# City of Mississauga Memorandium: City Department and Agency Comments

File(s): A469.24

Property Address: 1610 Kenmuir Ave

#### Appendix 1 – Transportation and Works Comments

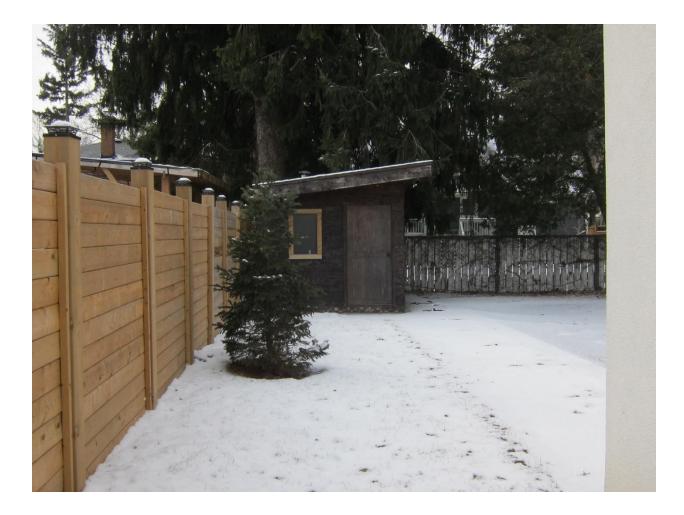
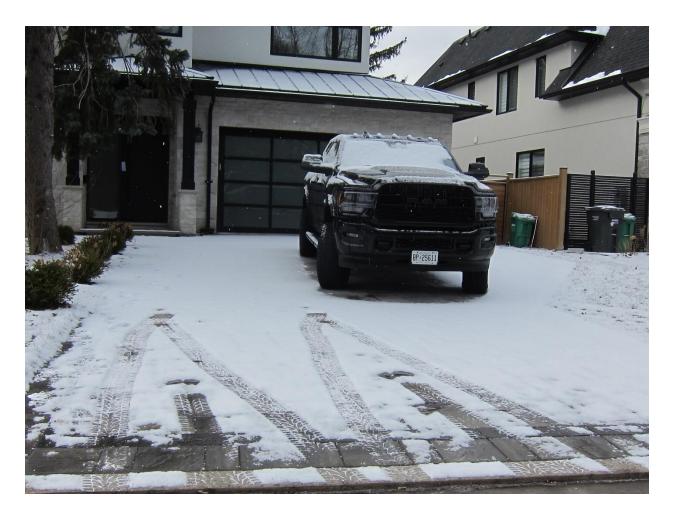
Enclosed please find pictures of the existing shed and driveway. We ask that the shed be equipped with an eaves trough and down spout directed in such a manor to not impact the adjacent properties.
